Canton Town Hall Reno
Project No.: 2023-001-02
Issue to: Bidders

Town of Canton, Owner
Contract Document Date: July 07, 2025
Addendum Date: March 31, 2026

END OF ADDENDUM 1

B1 ENLARGED WOMEN 107
1/4" = 1'-0"

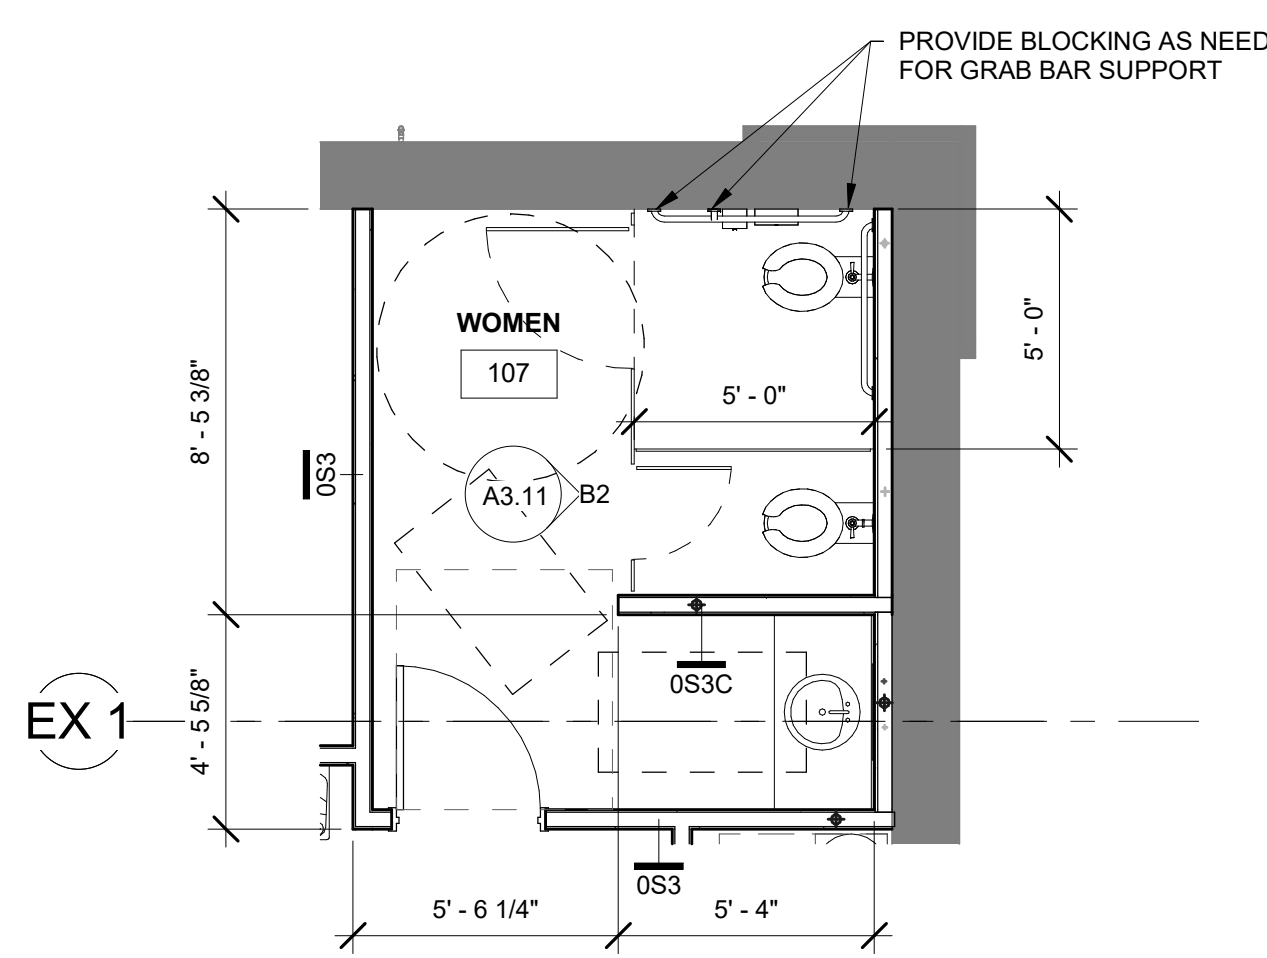
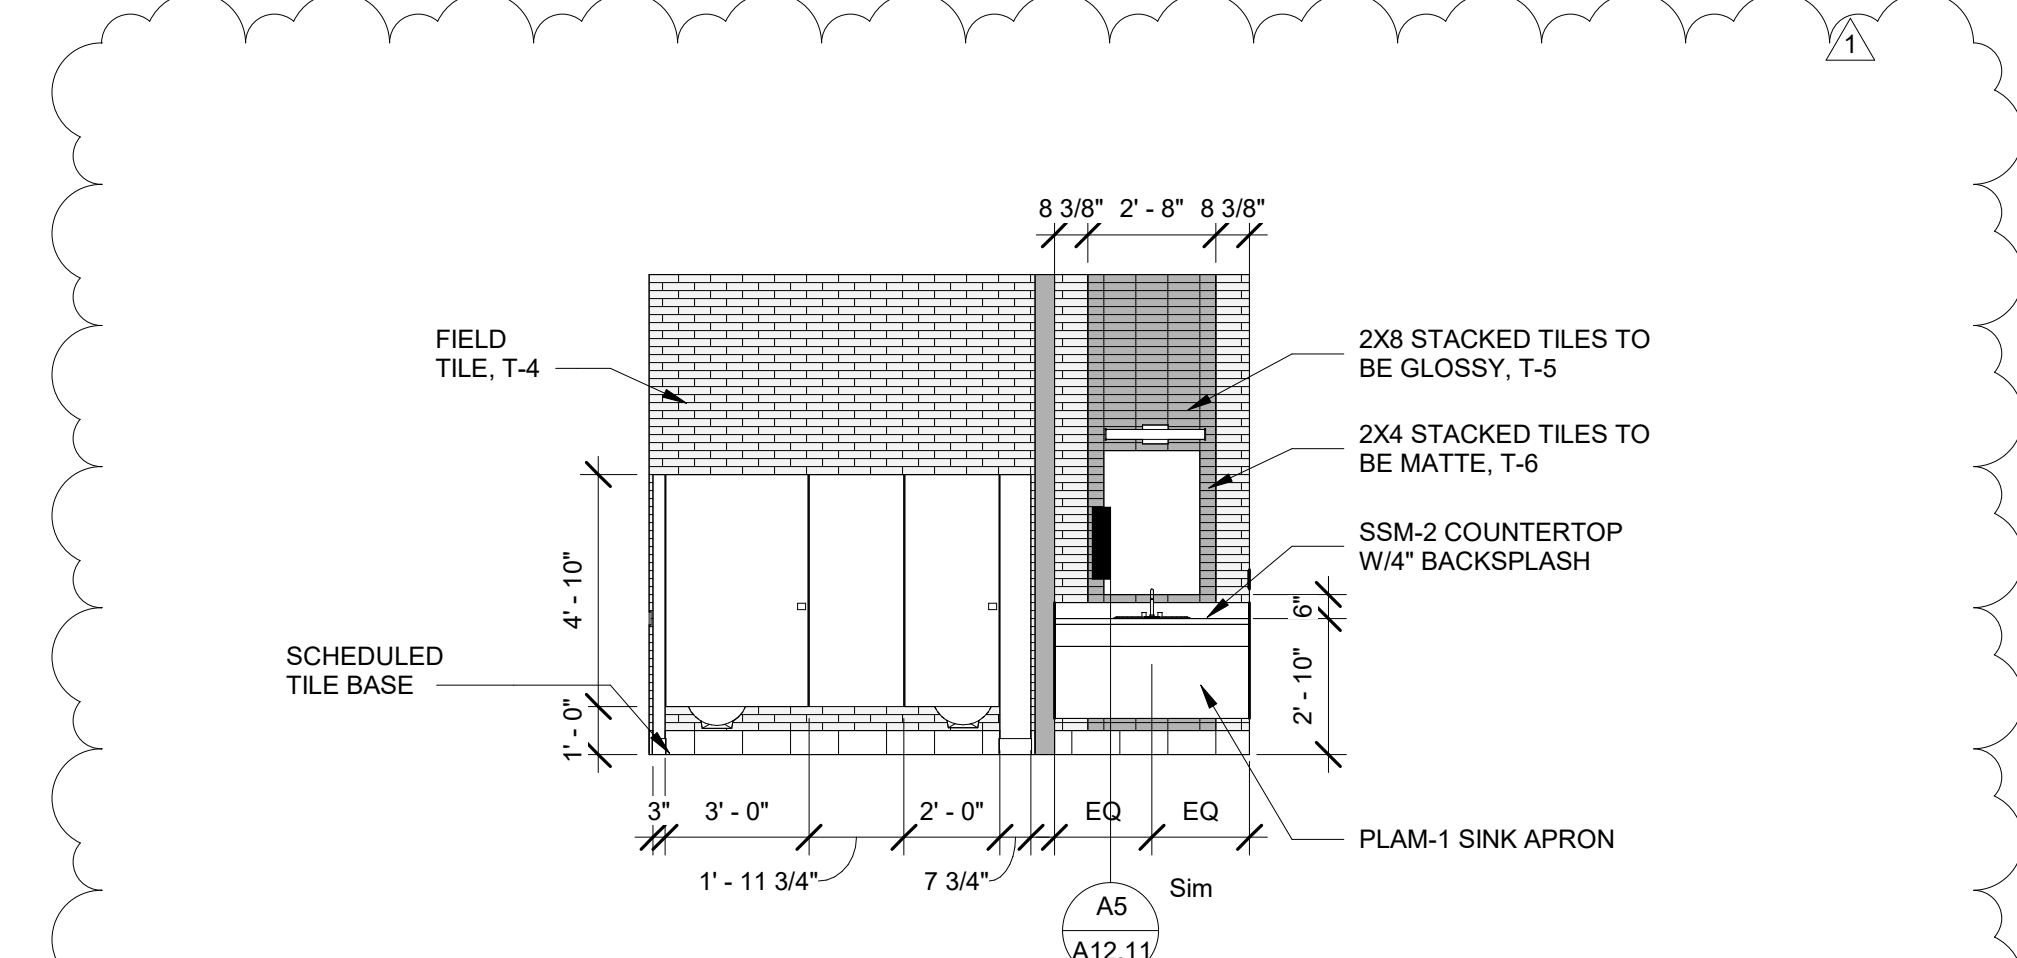
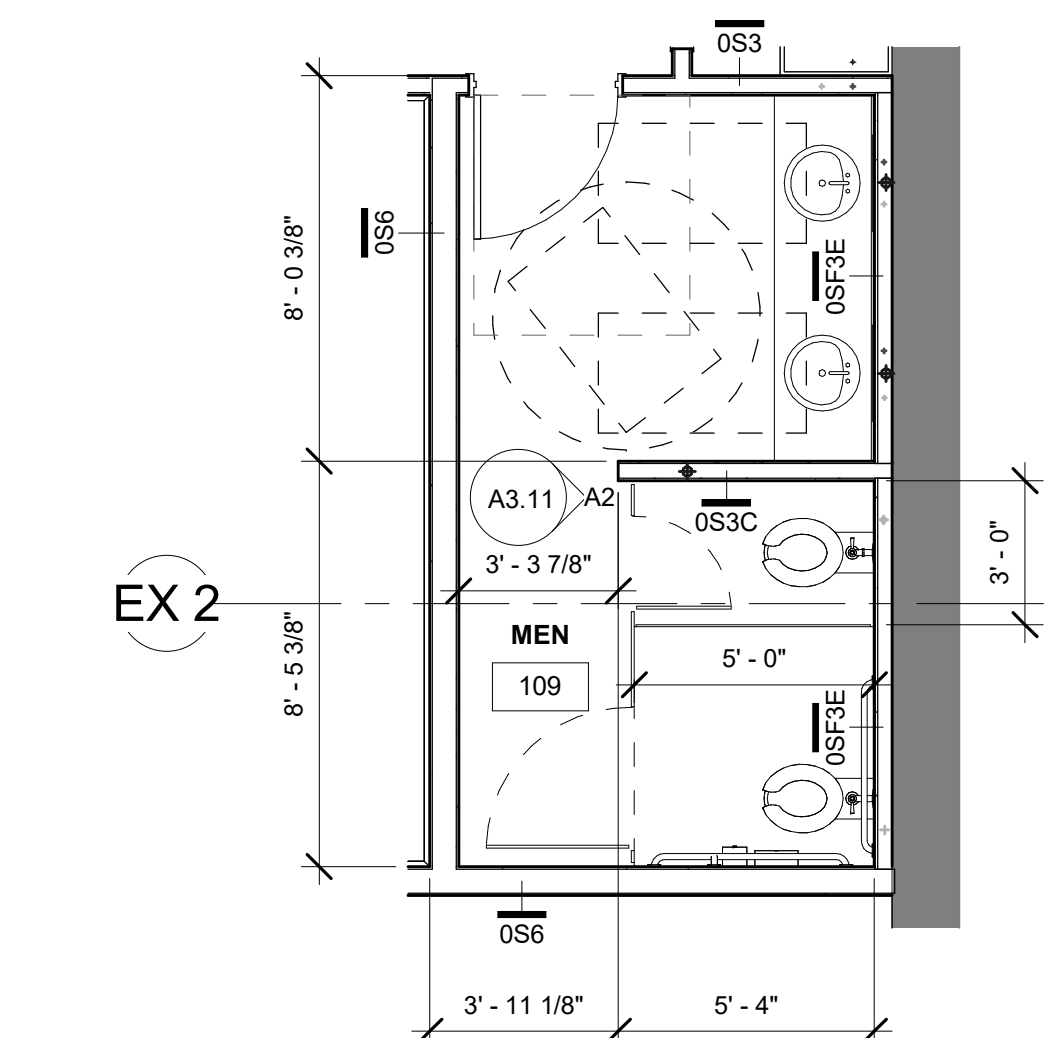
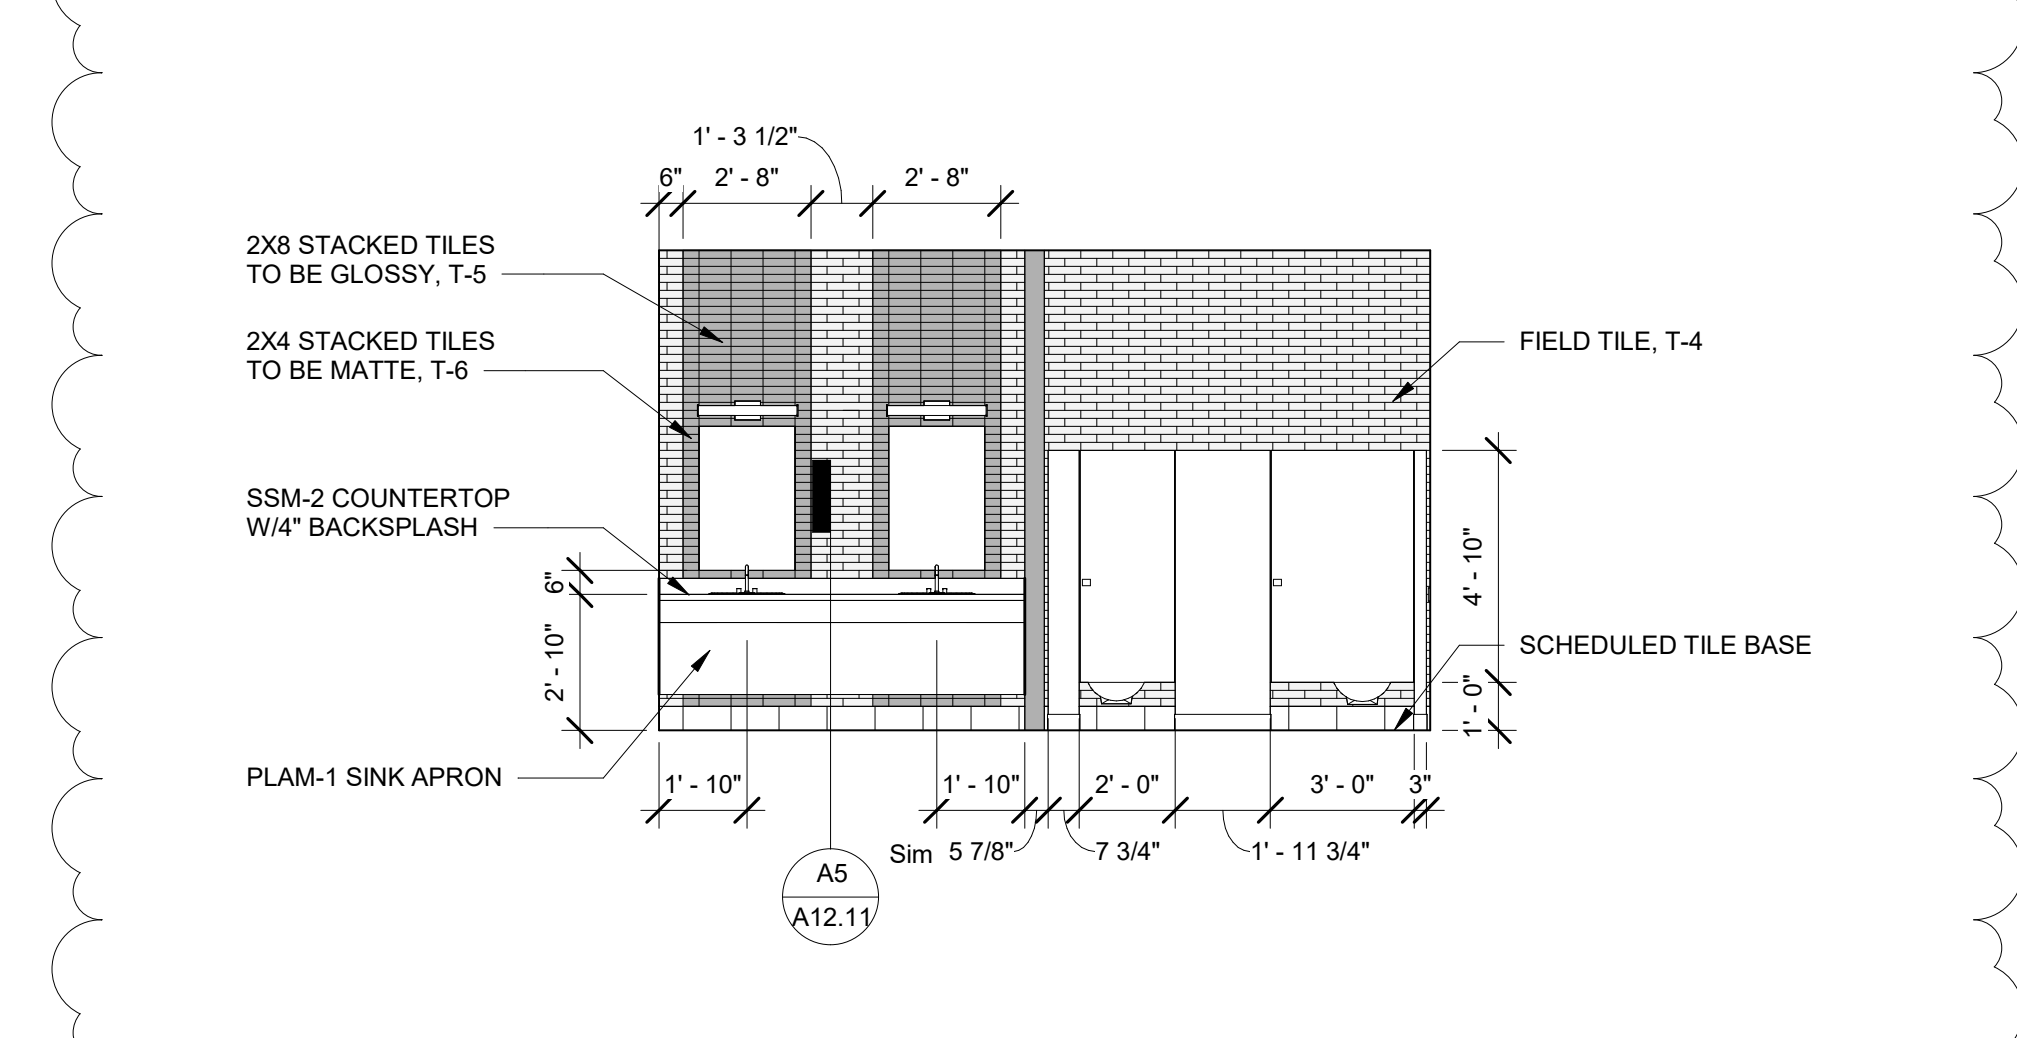
- c) Please confirm base in rooms 107 and 109. Schluter Dilex is the base for this room, however, this product is not a Please clarify the base in rooms 107 and 109. The TS-1 Schluter Dilex is the only "Base" called out for this room. However, this material is only applicable in wall tile/Floor tile transitions.
 - 1) See revised Drawings.
